U.S. ARMY CORPS OF ENGINEERS

Action ID: SAW-2010-01840 **County:** Orange

Incomplete Application Notification

Reference: Response to January 18, 2011 Notice of Incomplete Application
SAW-2010-01840
The University of North Carolina at Chapel Hill
Orange County
North Carolina

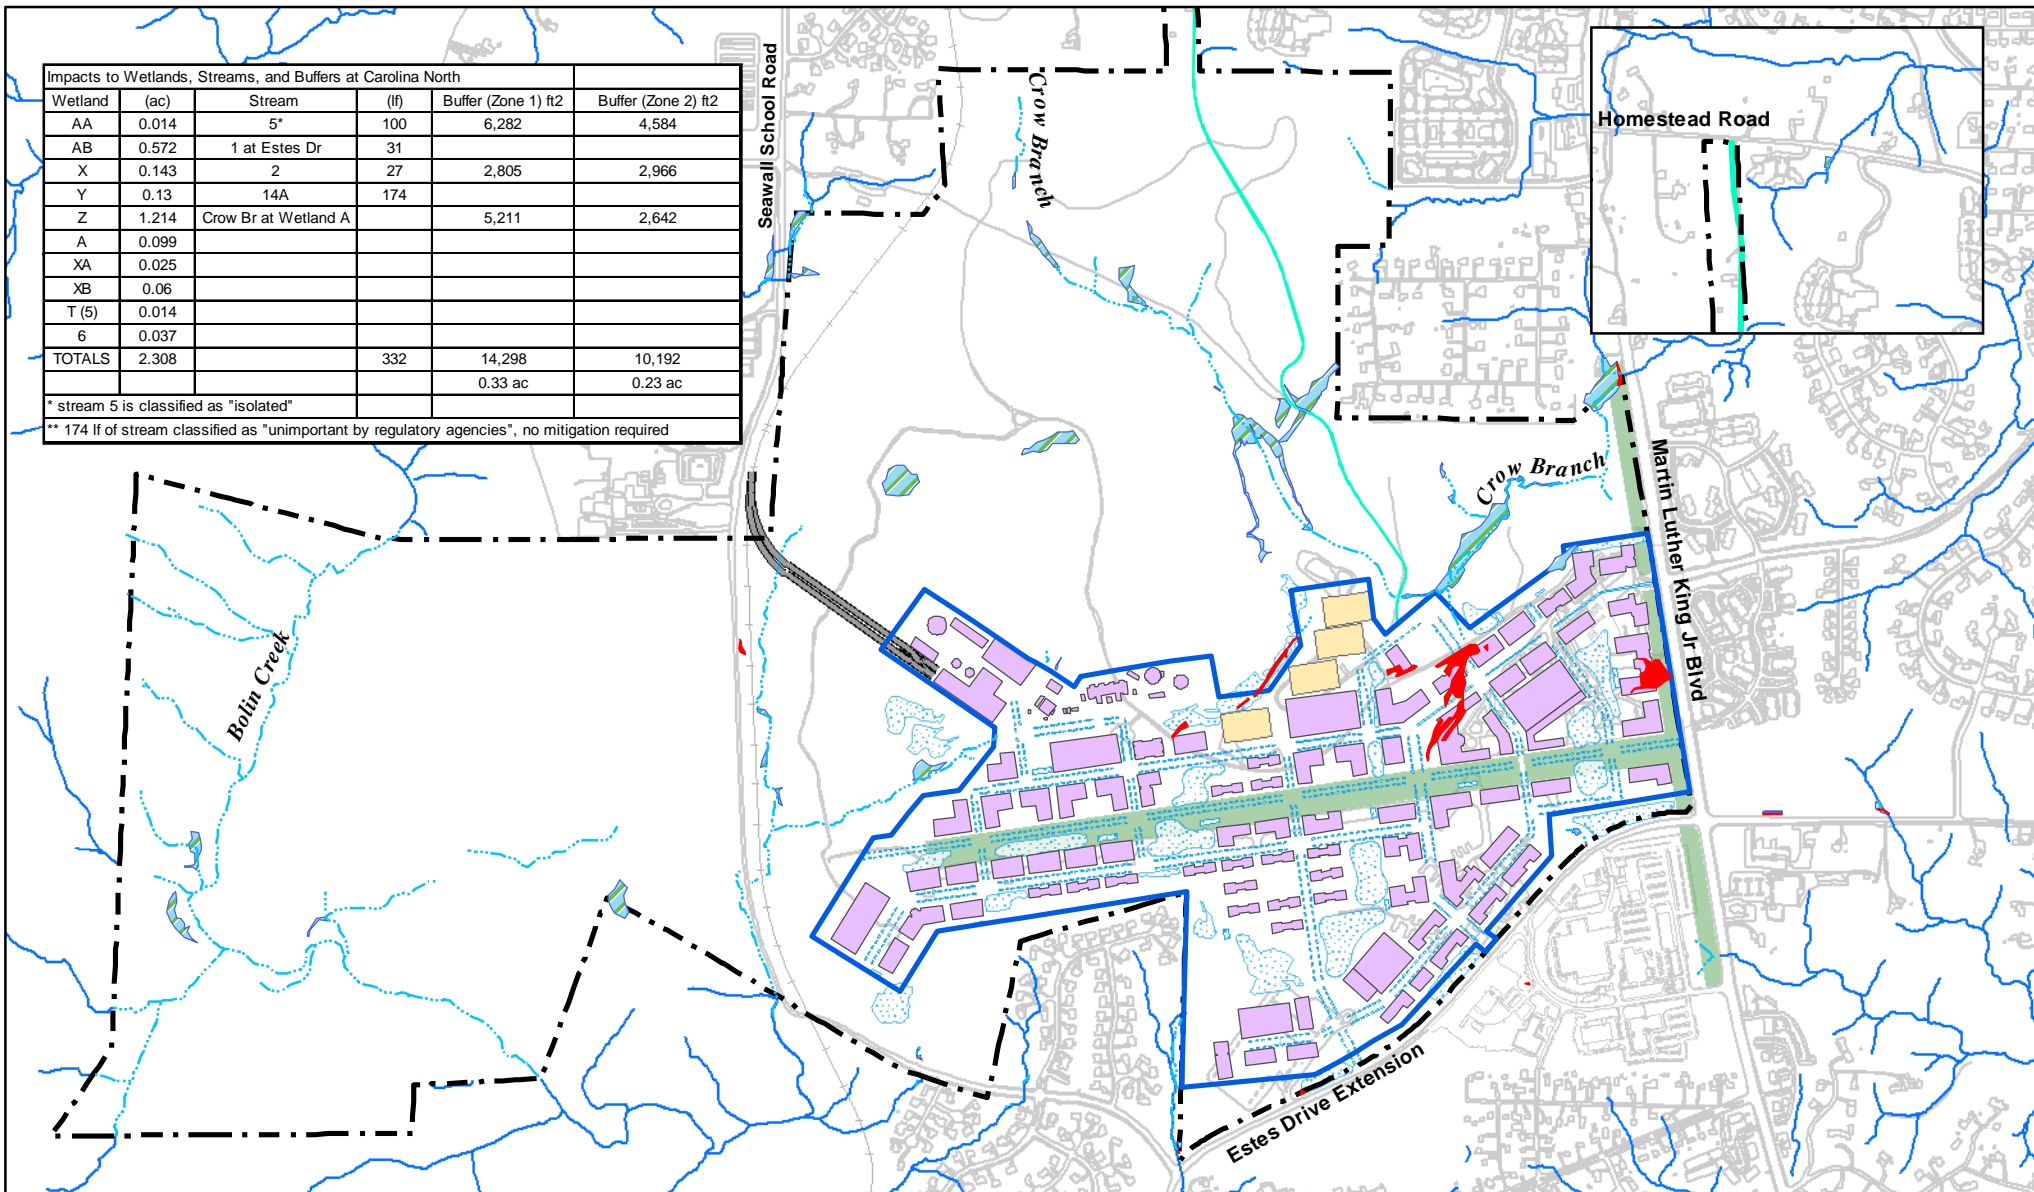
6. *The portion of stream 14A that is proposed for impacts was determined to have minimal aquatic function and therefore, the Corps will not require compensatory mitigation for impacts to that portion of stream. However, in Table D-2, you have excluded the 178 linear feet of impacts to stream 14A from the total amount of impacted streams. Please revise this table, as well as other portions of the application where the 178 linear feet of impacts to stream 14A has been omitted.*

Figure A-21 was revised to correct the previous total of 158 linear feet to 332 linear feet of total stream impact. Please remove the original version of Figure A-21 from the IP application and replace it with the attached Figure A-21, February 16, 2011, Revision 1.

FIGURE A-22

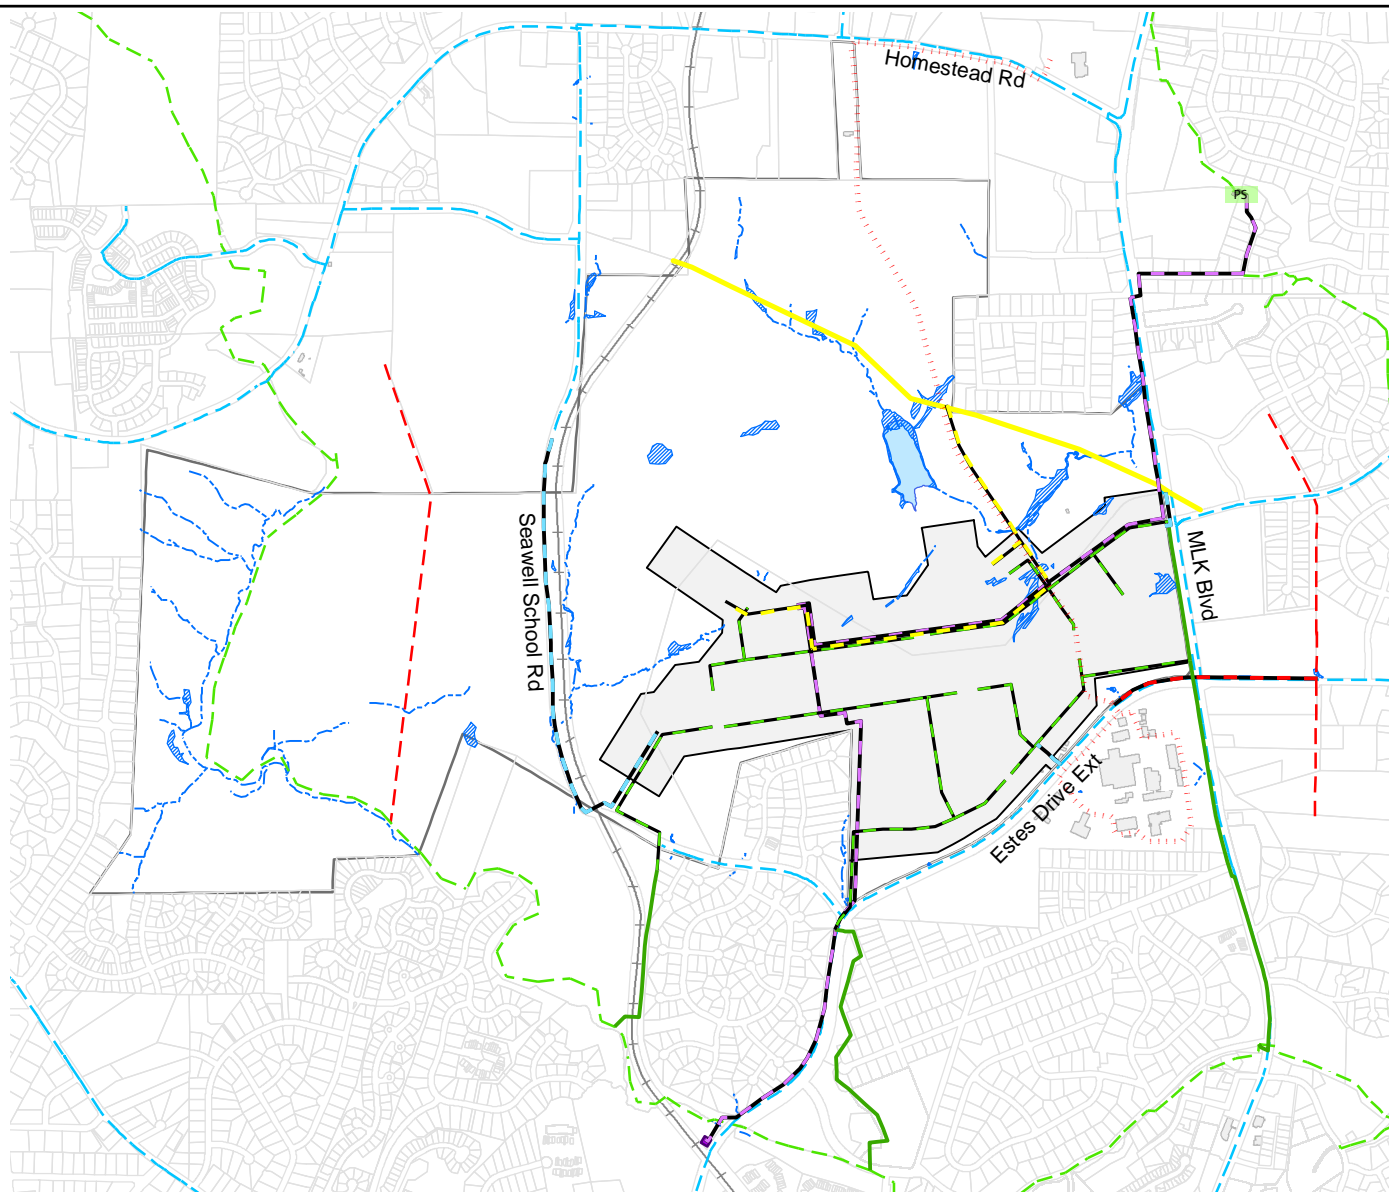
5. Figure A-22 indicates a number of proposed utility lines. Please indicate if these proposed lines connect to existing utilities or to other proposed utilities.

5. *Figure A-22 indicates a number of proposed utility lines. Please indicate if these proposed lines connect to existing utilities or to other proposed utilities.*

Figure A-22 has been revised to show the locations of the existing utilities to which the proposed utilities will connect. The proposed utilities and their connections are described below.

Please remove the original version of Figure A-22 from the IP application, and replace it with the attached Figure A-22, February 16, 2011, Revision 1.

FIGURE C-6

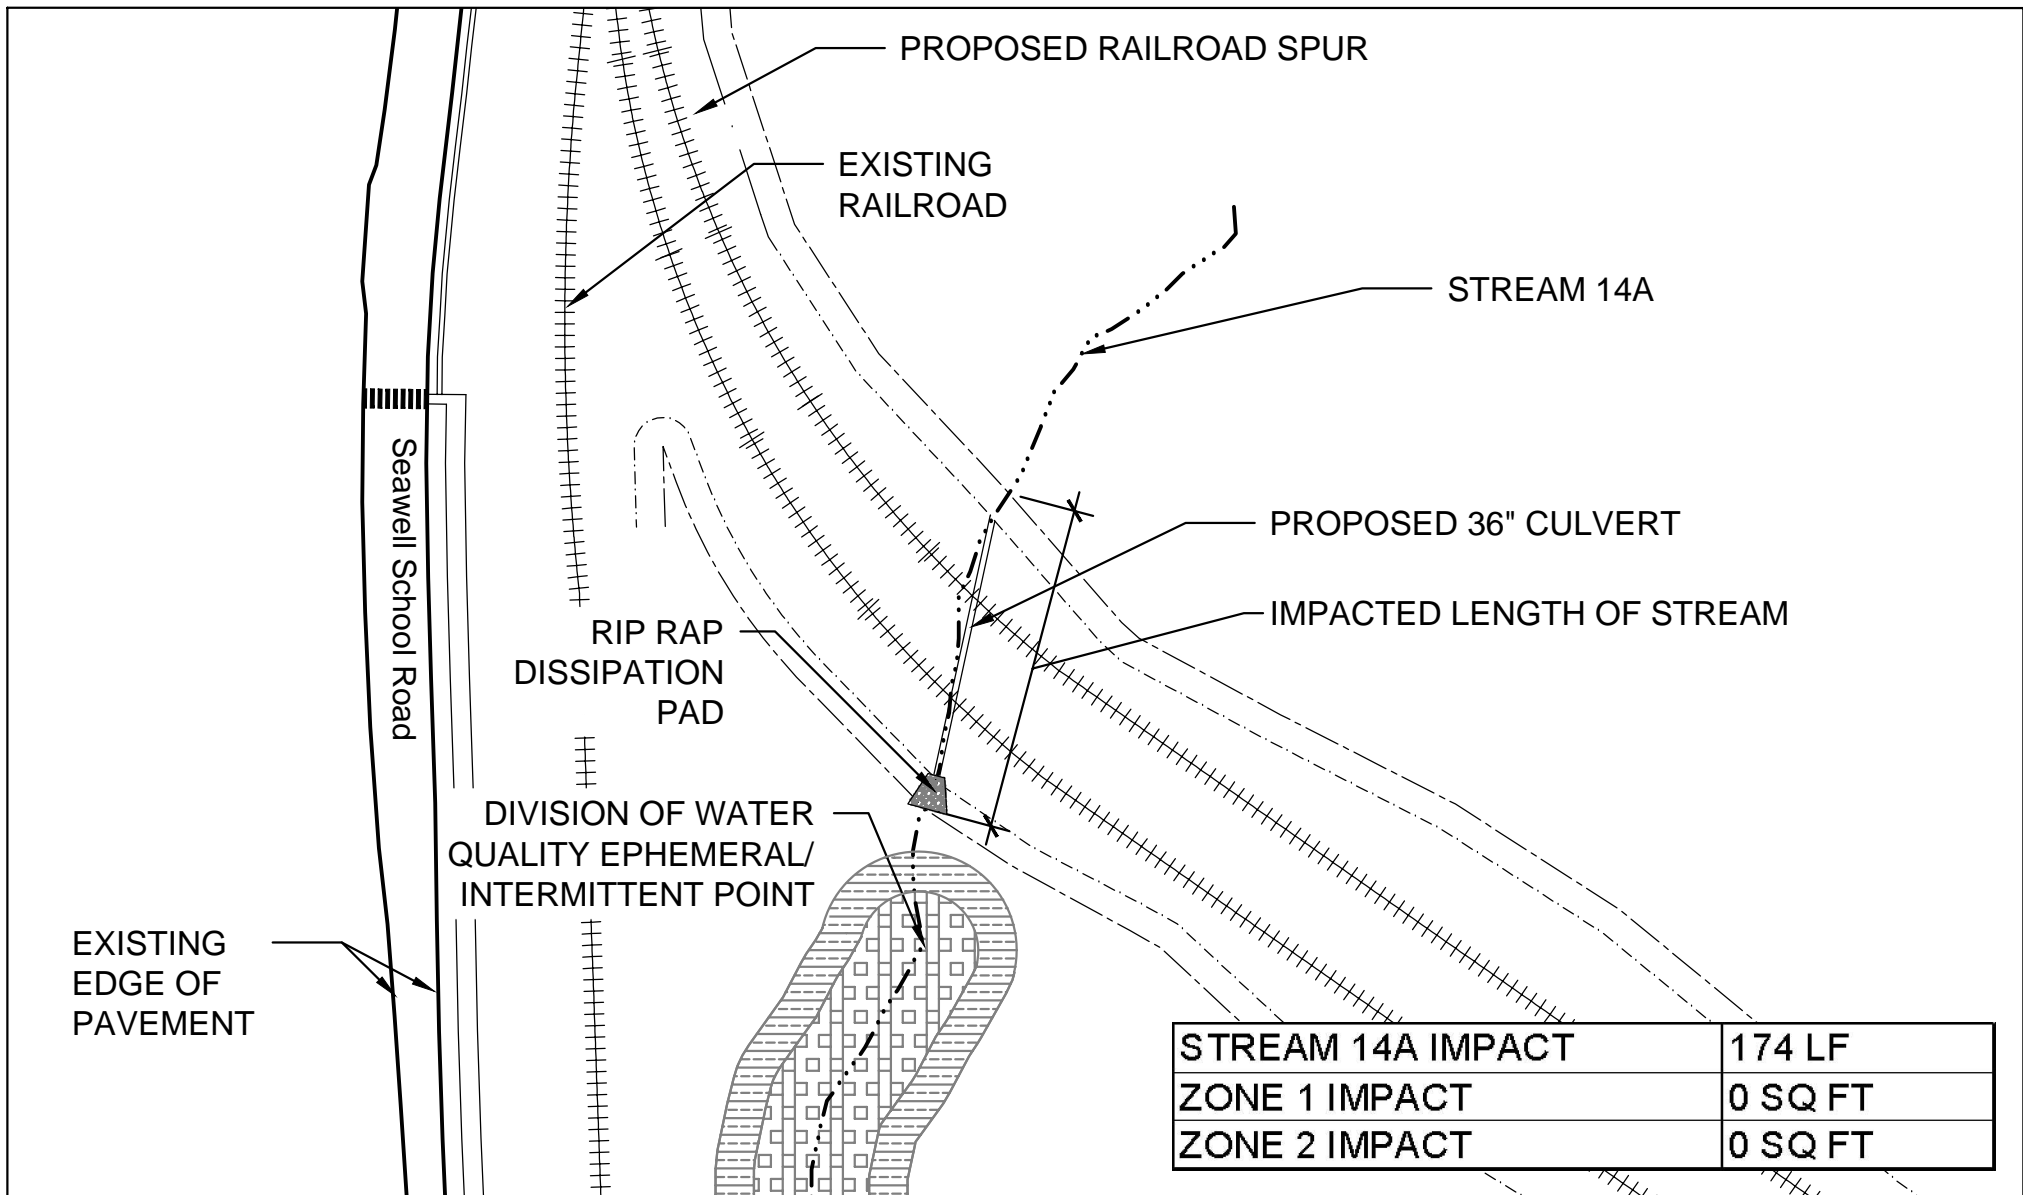
7. Your application does not indicate if you plan to construct rip rap dissipation at the proposed stream culvert modification sites. In many cases, the North Carolina Division of Land Quality will require dissipation pads as part of the sediment and erosion control plan. Please provide a brief discussion regarding the design of the proposed culverts and if there is a need for any dissipation pads. Specifically, you must indicate if it has been designed in accordance with the current North Carolina Erosion and Sediment Control Planning and Design Manual. This manual can be found at the following website: <http://www.dlr.enr.state.nc.us/pages/publications.html>. We recommend that you coordinate your design with the North Carolina Division of Land Quality. If you do plan to construct rip rap dissipation pads, please update the application and plans to indicate the proposed amount of rip rap at each impact location.

7. *Your application does not indicate if you plan to construct rip rap dissipation at the proposed stream culvert modification sites. In many cases, the North Carolina Division of Land Quality will require dissipation pads as part of the sediment and erosion control plan. Please provide a brief discussion regarding the design of the proposed culverts and if there is a need for any dissipation pads. Specifically, you must indicate if it has been designed in accordance with the current North Carolina Erosion and Sediment Control Planning and Design Manual. This manual can be found at the following website: <http://www.dlr.enr.state.nc.us/pages/publications.html>. We recommend that you coordinate your design with the North Carolina Division of Land Quality. If you do plan to construct rip rap dissipation pads, please update the application and plans to indicate the proposed amount of rip rap at each impact location.*

The North Carolina Division of Land Quality requirement for dissipation pads has been reviewed and is discussed below. Figure C-6 has been revised to show the riprap dissipation pad. The impacts have not changed as a result.

The proposed culvert to convey Stream 14A under the proposed railroad spur, shown in Figure C-6, is the only culvert that is not an upstream extension to an existing NCDOT culvert. The calculation methods from the current Manual were used to determine the required length of a rip rap dissipation pad for this culvert. The addition of a dissipation pad at the proposed crossing of Stream 14A did not increase the impact length previously calculated. Figure C-6 has been revised to show this dissipation pad. Please remove the original version of Figure C-6 from the IP application, and replace it with the attached Figure C-6, February 16, 2011 Revision 1.

FIGURE C-9

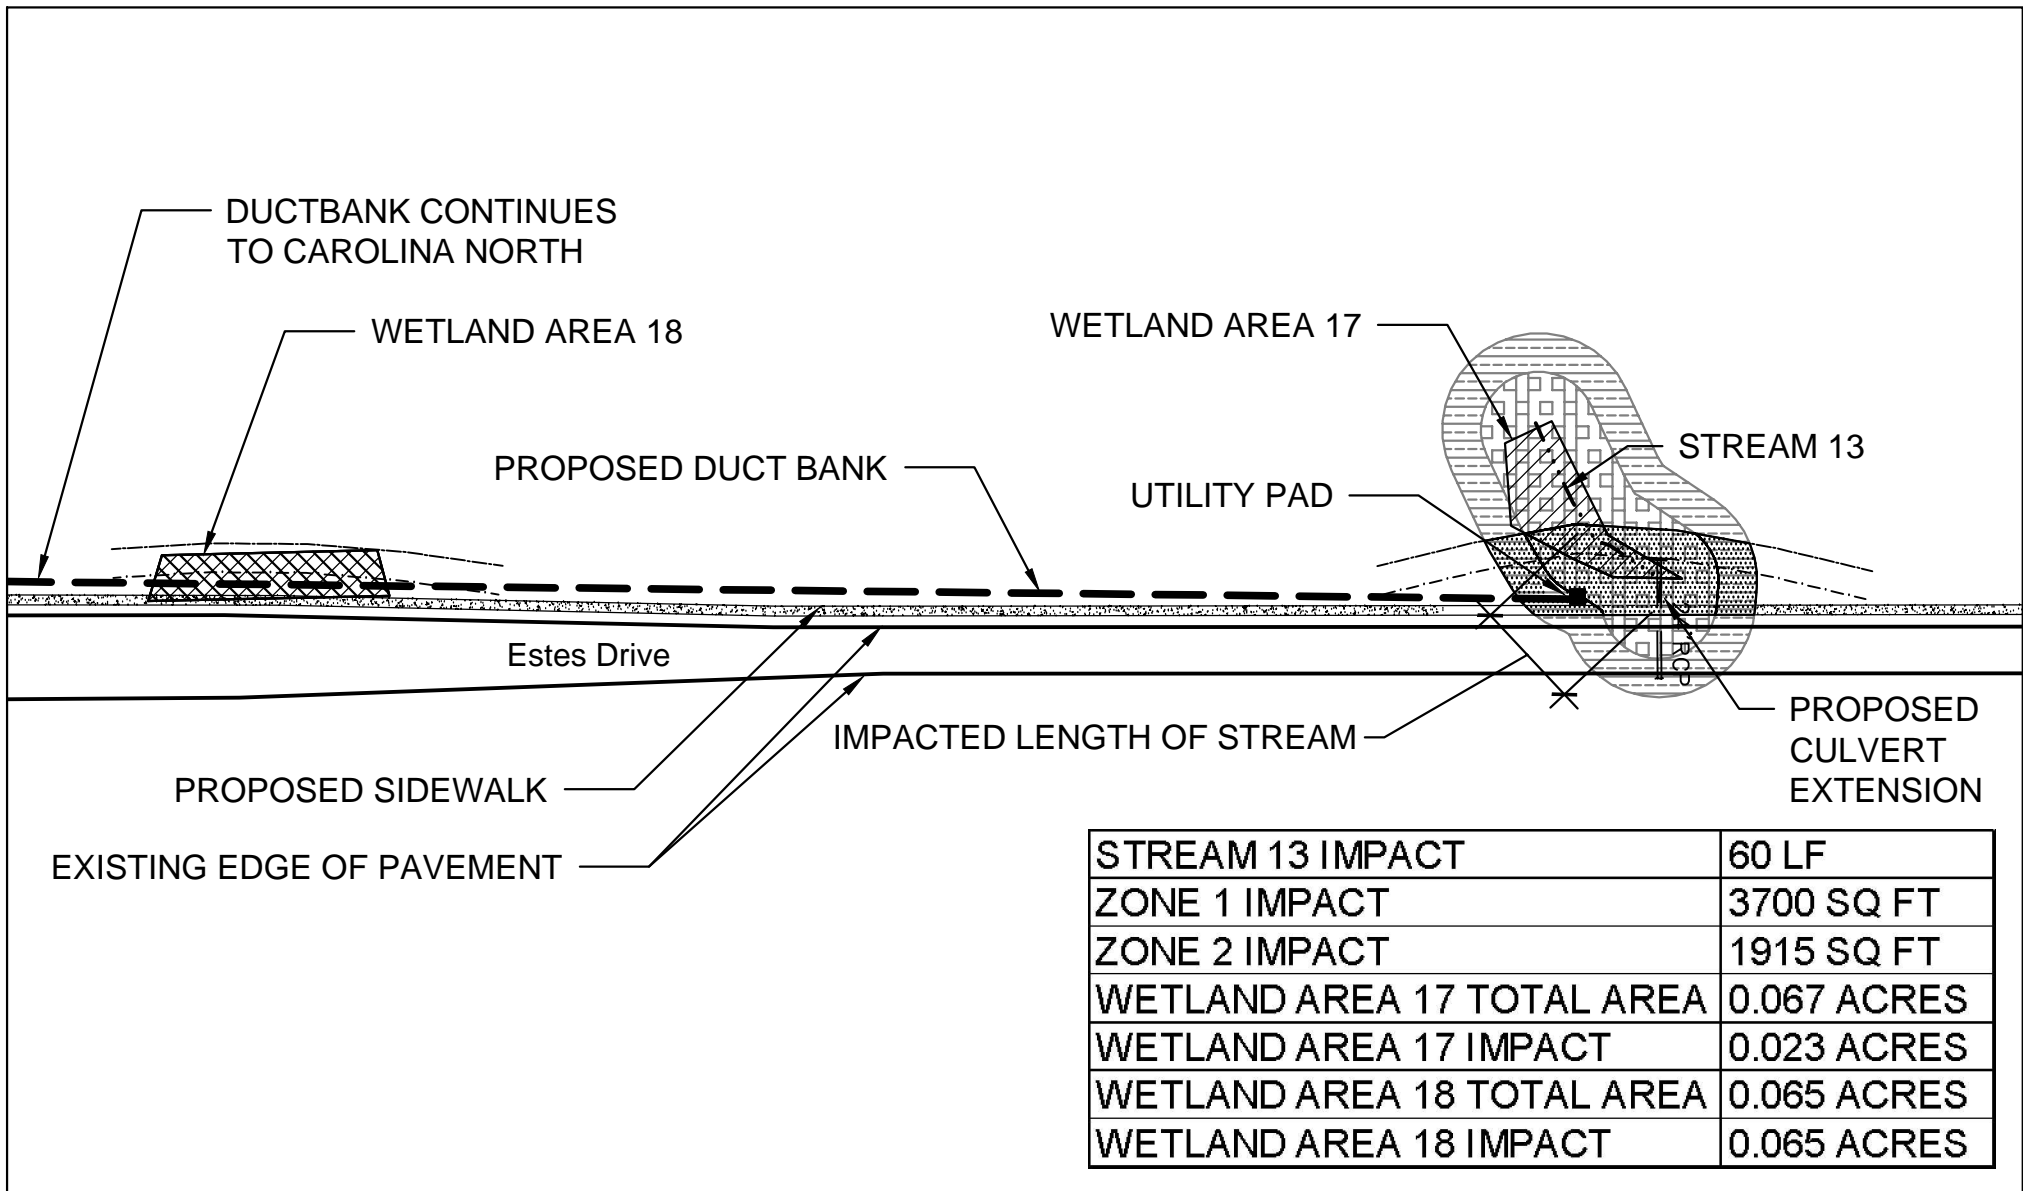
4. On plan sheet C-9, please indicate if the proposed fill is temporary or permanent. If it is temporary, please include a restoration plans. Also, if it is a temporary impact (fill), no compensatory mitigation is required, provided the impact area is returned to pre-construction contours.

4. *On plan sheet C-9, please indicate if the proposed fill is temporary or permanent. If it is temporary, please include a restoration plans. Also, if it is a temporary impact (fill), no compensatory mitigation is required, provided the impact area is returned to pre-construction contours.*

The crossing of Bolin Creek is not a temporary or permanent impact. Riprap will be placed over the pipe and will fill the trench, with the top of the riprap at the pre-construction elevation of the stream substrate. The fill is shown because the North Carolina Division of Water Quality (DWQ) considers riprap placed in a stream a permanent impact regardless of the final elevation of the riprap. Therefore, this impact was shown as a permanent impact in the application. Figure C-9 has been revised. Please replace Figure C-9 with the attached revised Figure C-9, February 16, 2011, Revision 1.
